# Stage 03: Report to the Authority

## GC0088 - Voltage Unbalance

GC0088 Voltage  
Unbalance Report to the  
Authority

Fig 3- PPS and NPS Power Loss in Combined Generator and its Transformer

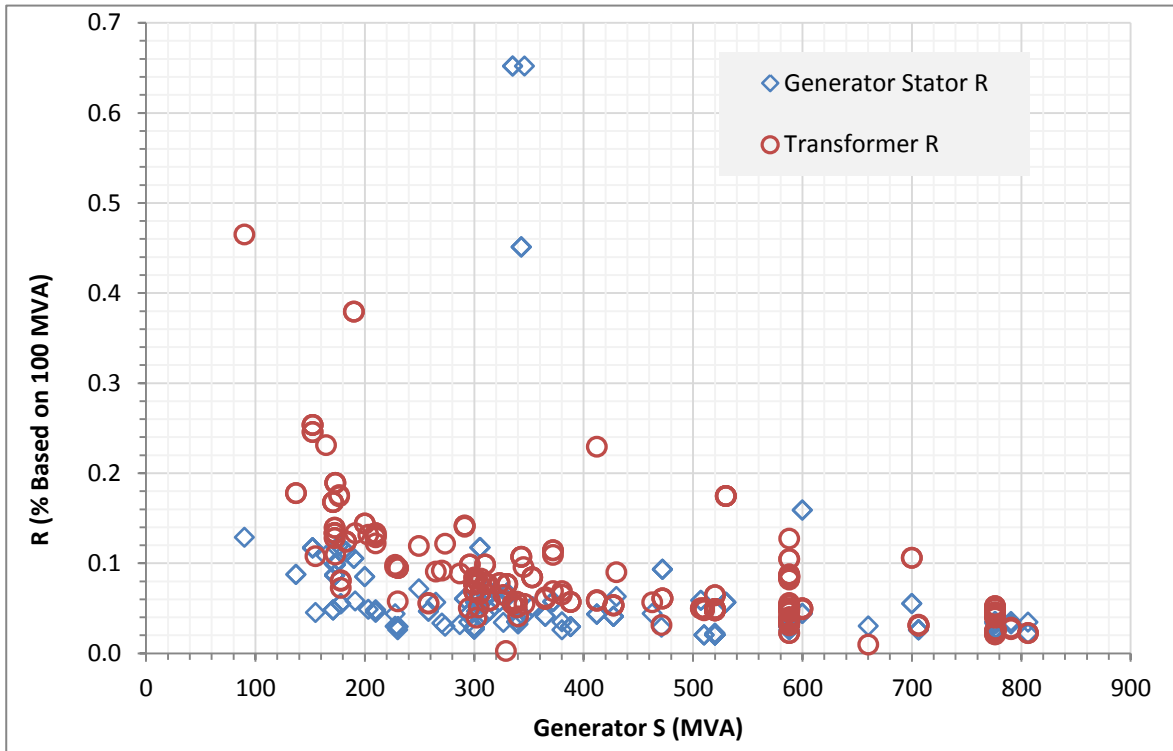
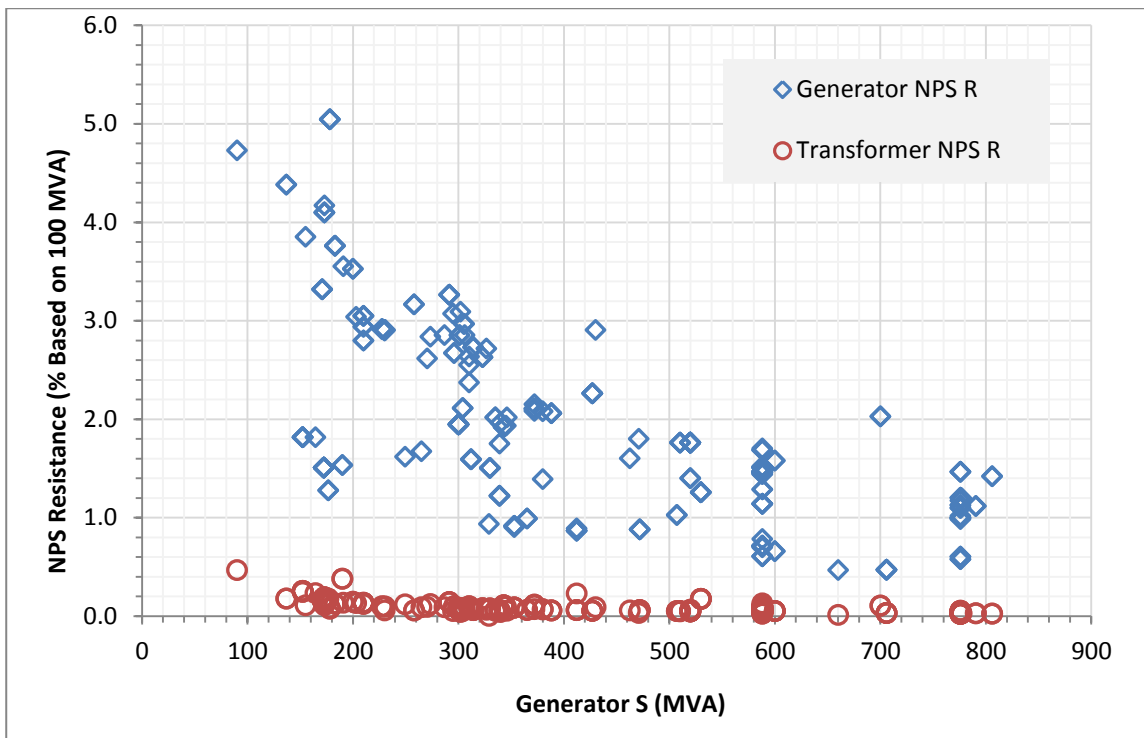
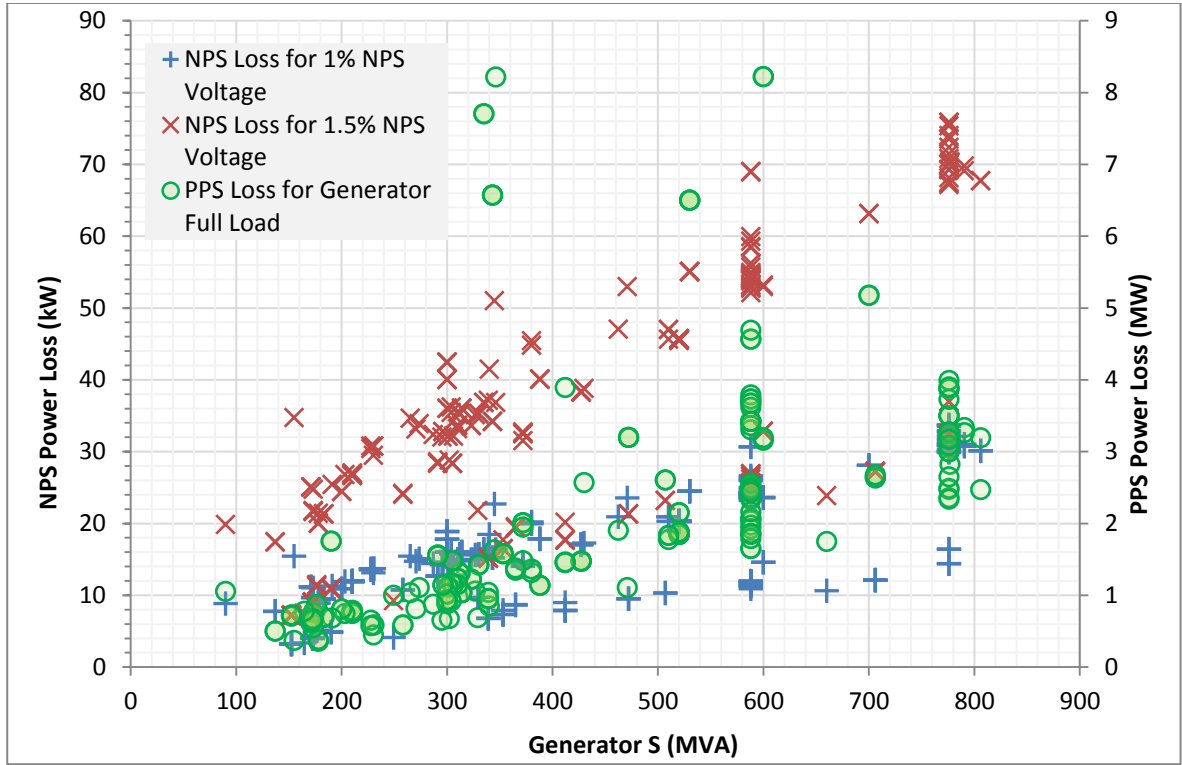
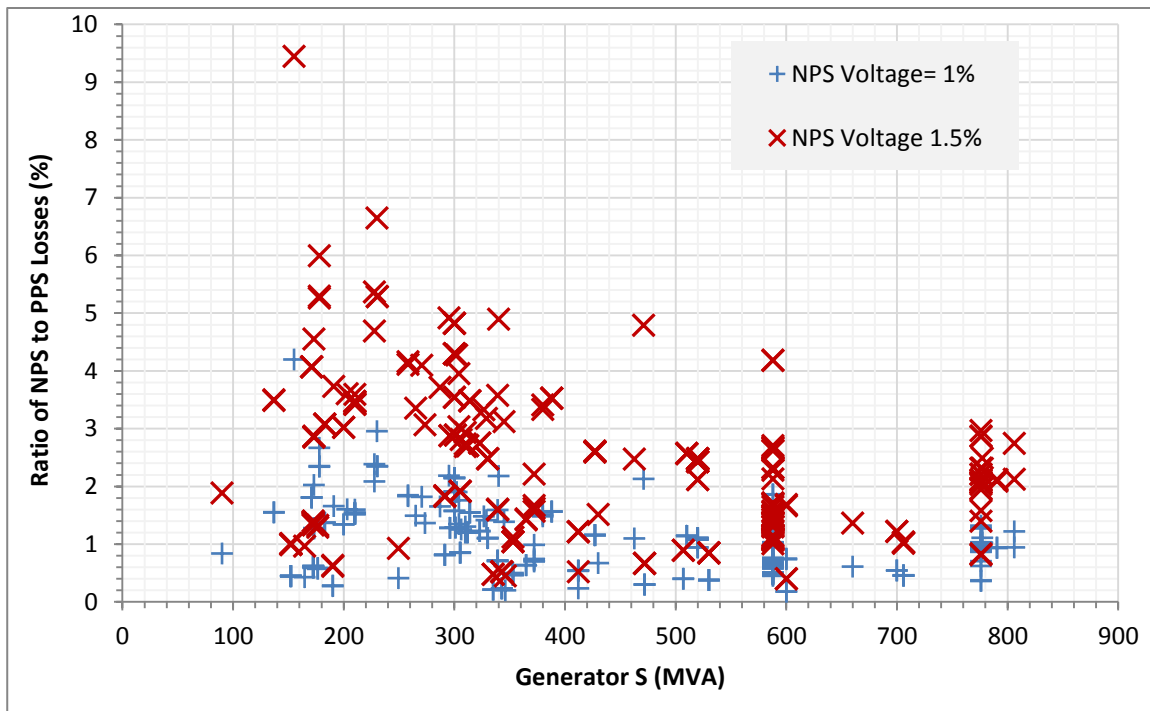
By email dated 9<sup>th</sup> July 2015, RWE raised concerns about the proposed increase in the negative phase sequence (nps) voltage limit in the Grid Code to 1.5% causing additional losses in rotating plants and hence operational costs for the generator companies. The email is given in Appendix A for ease of reference.

Just one comment on the draft report – if the phase unbalance in England and Wales is increased from 1% to 1.5%, the negative phase sequence (NPS) currents in generating units would increase, causing additional heating, a slightly reduced efficiency and increased operating cost. Whilst the report Para 2.1.4 recognises that this cost would be minimal for generators, it is assumed from the reference to design that this refers to the generator's capital cost. Whilst Question 8 asks consultees for evidence that additional (operational) costs to generators would outweigh the benefits, the generator is unable to answer this question in isolation. It would therefore be helpful if the report gave an indication of the likely extent that the greater phase unbalance would occur on the transmission system in E&W and also an estimate of the total operational costs that would be incurred by generating units operating less efficiently.

It is concluded that the impact on overall generator losses resulting from the proposed change to the Grid Code nps limit from 1% to 1.5% will be small compared to the benefit of the proposal.

Figure 3 shows the power loss in the machines and transformers considered both for nps and pps components. For calculating the pps power loss it is assumed that machine is supplying the rated apparent power. The nps power losses are shown for both 1% and 1.5% nps voltage.

Note that the nps power loss for nps voltage of 1.5% is 2.25 times higher than the power loss for nps voltage of 1.0%. In general the higher the machine rating the higher the nps and pps power loss.

Figure 4 illustrates the nps power loss in the generator and its transformer as percentage of the pps power loss at machine rating. It can be seen that for machines with 300 MVA rating and above the nps power loss is below 5% of the pps power loss. For most machines with lower ratings this increases to below 7% with one case only of 9.5%. This odd case may be due to data inaccuracy.
